TRANSMITTAL LETTER

**Revisions to
Traffic Standards – Signals TC-8800 Series
December 2011 Edition, Change No. 1**

TRAFFIC STANDARDS—SIGNALS TC-8800 SERIES

PUB 148 (6-23)

MISCELLANEOUS
TRAFFIC SIGNAL SUPPORT-PEDESTAL
PEDESTRIAN PUSHBUTTON

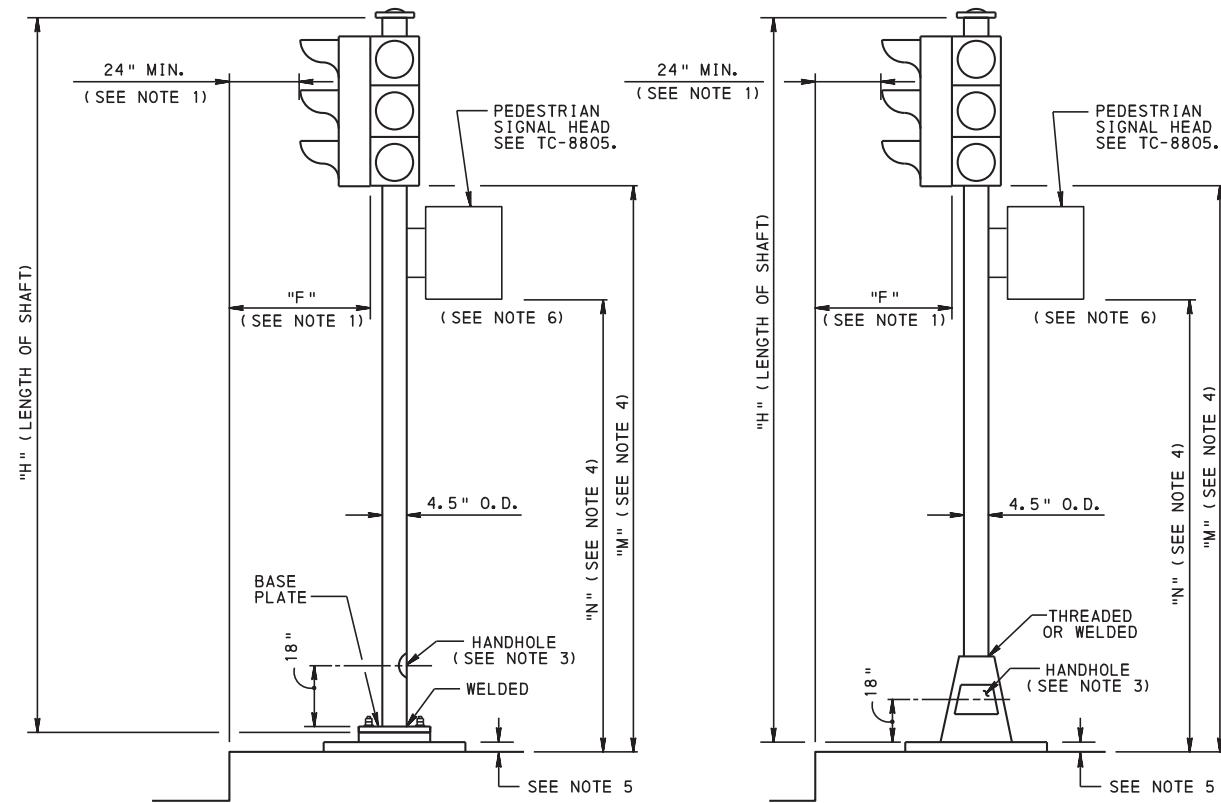
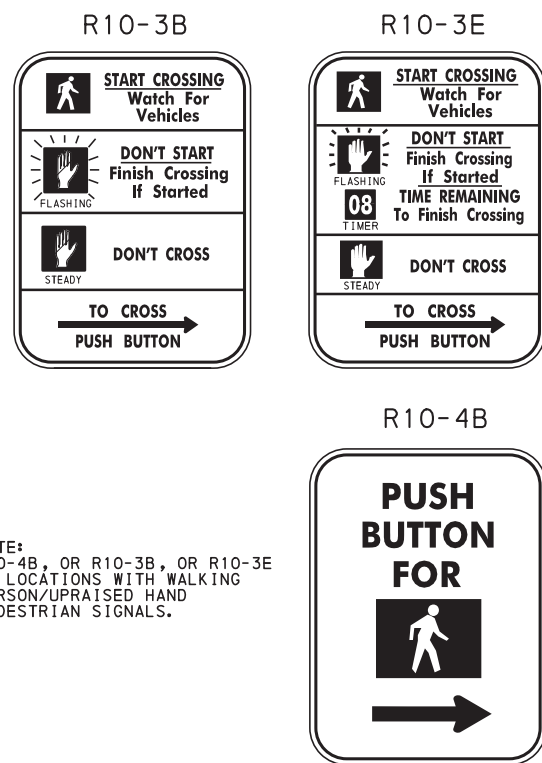
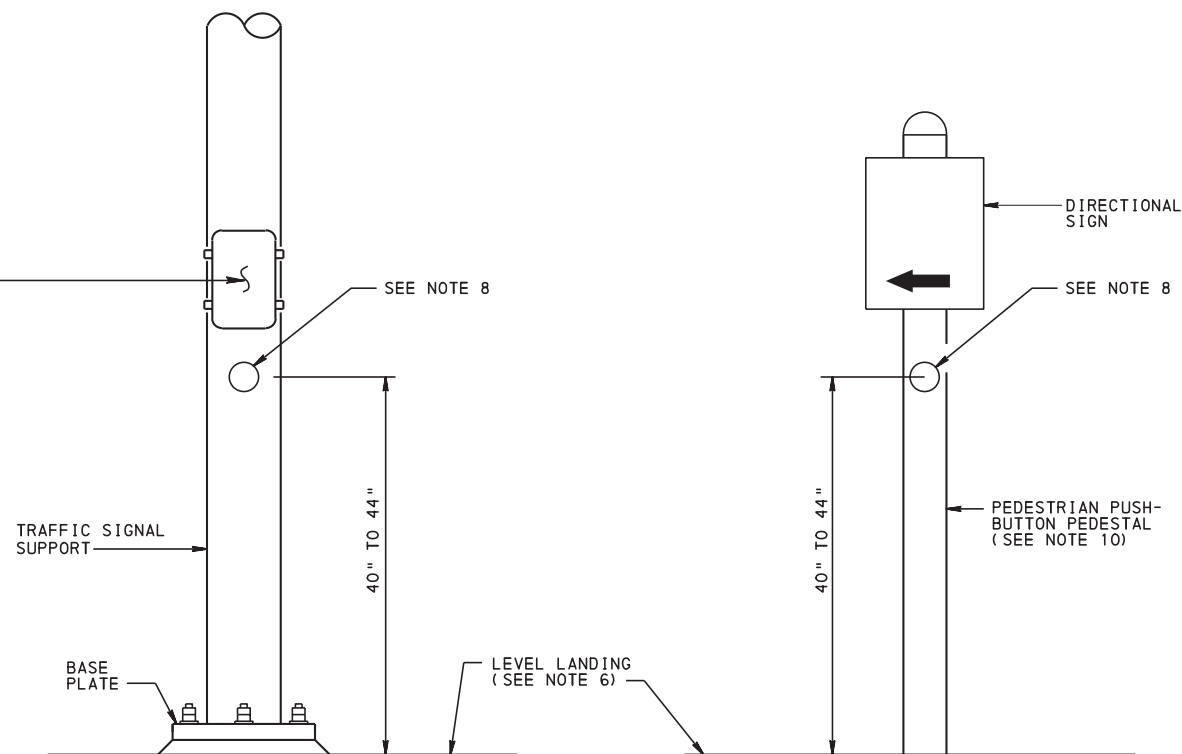
TC-8803	1	<p>Updated Traffic Signal Support – Pedestal Plate Base Detail as follows:</p> <p>-Depicted bolt pattern on Elevation View pedestal base plate.</p> <p>Updated Pedestrian Pushbutton Vertical Placement Detail as follows:</p> <p>-Depicted bolt pattern on Elevation View of signal pole base plate. Bolts depicted represent six bolt pattern implemented in 2011 TC-8801</p> <p>Updated Notes as follows:</p> <ul style="list-style-type: none"> • Revised the last sentence of Note 5 from “SEE DETAIL C ON SHEET 9 OF TC-8801.” to “SEE DETAIL C ON SHEET 10 OF TC-8801.”
TC-8803	2	<p>Updated Pedestrian Pushbutton Mounting Details Type B as follows:</p> <p>-Revised “PEDESTRIAN SIGN” callout to “PUSHBUTTON SIGN.”. Callout was revised to be consistent with similar callouts on Type A, Type C, and Type F Details.</p> <p>Updated Notes as follows:</p> <ul style="list-style-type: none"> • Revised the last sentence of Note 4 from “SEE DETAIL C ON SHEET 9 OF TC-8801.” to “SEE DETAIL C ON SHEET 10 OF TC-8801.”

REINFORCED PLASTIC MORTAR OR
HIGH-DENSITY POLYMER CONCRETE
JUNCTION BOX, TYPE JB-26
TYPE JB-27 OR TYPE JB-30

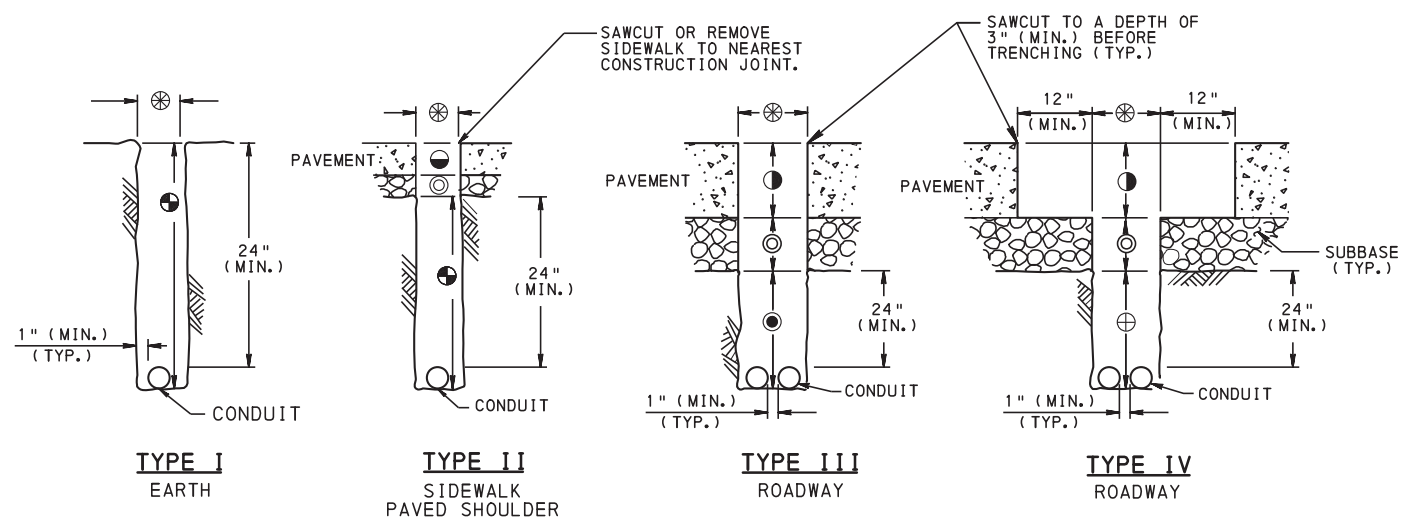
TC-8804	2	<p>Updated Junction Box, Type JB-26 and Junction Box, Type JB-27 Details as follows:</p> <p>-Revised Junction Box Details to a typical detail for cast iron or steel and a typical detail for reinforced plastic mortar or high-density polymer concrete with dimensions for each detail labeled as variables. Identified corresponding required JB-26 and JB-27 dimensions in tabular format. Added JB-30 dimensions to table as applicable.</p> <p>Updated Typical Junction Box Installation Junction Box in Paved Surface Detail as follows:</p> <p>-Revised label of detail from ‘JUNCTION BOX IN PAVED SURFACE’ to “JUNCTION BOX IN PAVED SURFACE AND SIDEWALK”</p> <p>Updated Trench and Backfill Detail as follows:</p> <p>-Revised fifth symbol note from “BACKFILL AS SPECIFIED IN SECTION 954, PUBLICATION 408” to “BACKFILL AS SPECIFIED IN SECTION 910.3 (c), PUBLICATION 408”</p> <p>Updated Notes as follows:</p> <ul style="list-style-type: none"> Revised the first sentence of Note 2 from “JUNCTION BOXES – USE JB-26 AND JB-27 ONLY IN AREAS NOT SUBJECT

TO VEHICULAR TRAFFIC.” to “JUNCTION BOXES – USE JB-26, JB-27 AND JB-30 ONLY IN AREAS NOT SUBJECT TO VEHICULAR TRAFFIC ”	
TC-8805	1	<p>Updated Visor Types for Vehicular Signal Head Details as follows:</p> <ul style="list-style-type: none"> -Removed Full-Circle Visor Detail -Added Dimension B to show visor lengths in lieu of describing in a note -Added a visor dimension table^o for visor dimensions A and B -Revised detail note from “THE VISOR SHALL BE A MINIMUM OF 9.5” FOR A 12” SIGNAL LENS AND 7” FOR AN 8” SIGNAL LENS WITH A DOWNWARD TILT OF 3.5 DEGREES” to “THE VISOR SHALL HAVE A DOWNWARD TILT OF AT LEAST 3^o ” <p>Updated Backplate for Vehicular Signal Head Detail as follows:</p> <ul style="list-style-type: none"> - Revised “5” MIN” callouts to “5” - 8”.”. - Revised Backplate detail to show reflective yellow border and added callout “2” MIN. FLOURESCENT YELLOW RETROREFLECTIVE BORDER” - Added note below detail label which reads “*BACKPLATE CONFORMING TO PUBLICATION 408 SECTION 955.2 (B) 3 SHALL BE ONE PIECE ALUMINUM” <p>Updated Pedestrian Signal Head Detail as Follows:</p> <ul style="list-style-type: none"> -Corrected spelling of word “SHOULD” in bottom note

ALTERNATE SENSOR INSTALLATION - LOOP DETECTOR

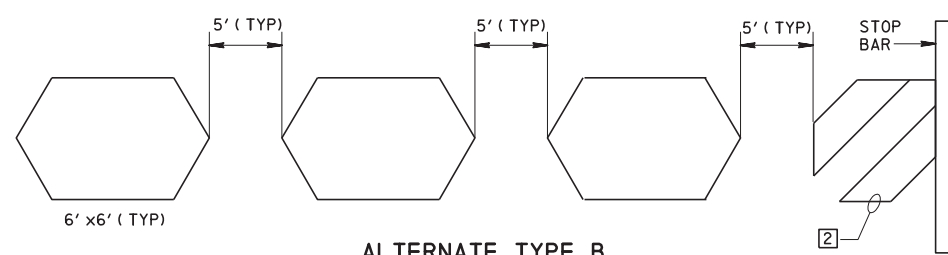
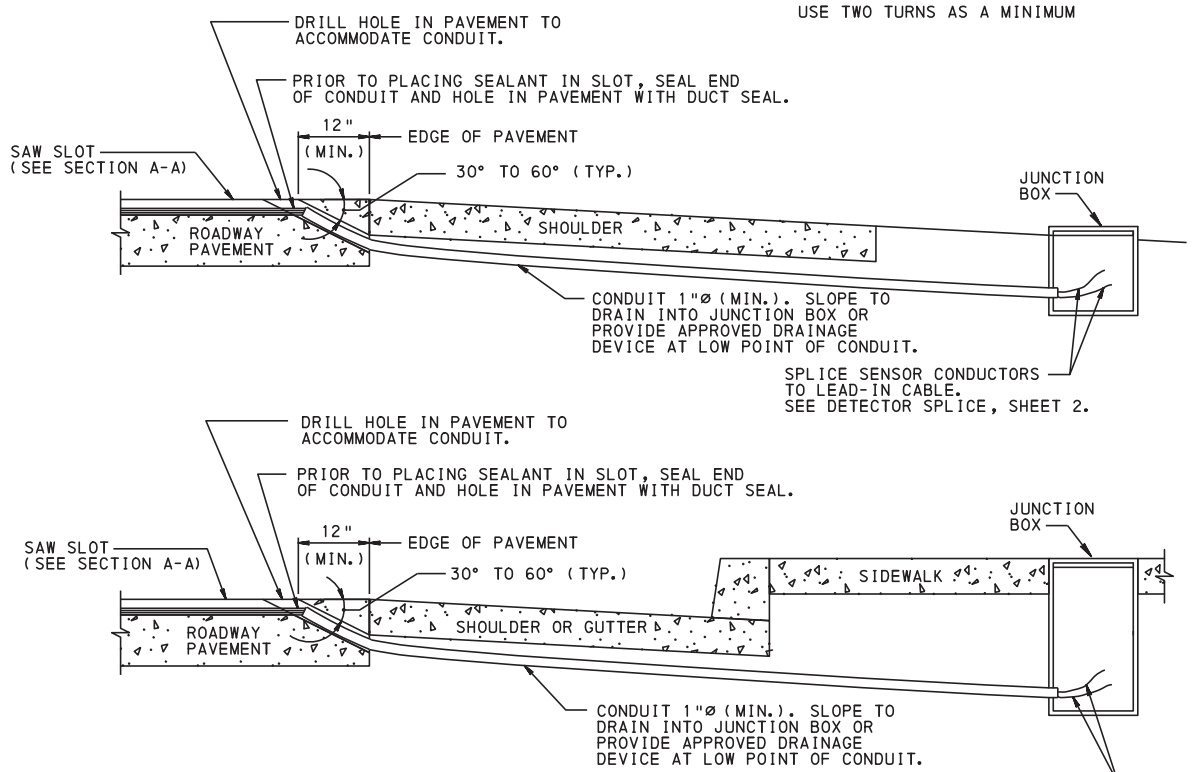
TC-8806	1	<p>Updated Typical Sensor Installation – Loop Detector Section A-A Detail as follows:</p> <ul style="list-style-type: none"> -Removed detail and replaced with a detail depicting installation of loop wire with backer rods. - Revised detail note from “NO MORE THAN FOUR CONDUCTORS SHALL BE PLACED IN A SLOT. FOUR CONDUCTORS SHOWN FOR ILLUSTRATION PURPOSES ONLY.” to “THREE CONDUCTORS SHOWN FOR ILLUSTRATION PURPOSES ONLY.” 	
TC-8806	2	<p>Updated Detector Splice Alternate A Detail as follows:</p> <ul style="list-style-type: none"> -Revised callout from “SEALANT (SEC. 1104.07 (a) 1, PUBLICATION 408)” to “SEALANT (SEC. 956.2 (b) 1, PUBLICATION 408)” <p>Updated Detector Splice Alternate C Detail as follows:</p> <ul style="list-style-type: none"> -Revised last line of note from “SEC. 1104.07 (a) 4, PUBLICATION 408.” to “SEC. 956.2 (b) 4, PUBLICATION 408. 	
All		Revised “Bureau of Maintenance and Operations” to “Bureau of Operations”
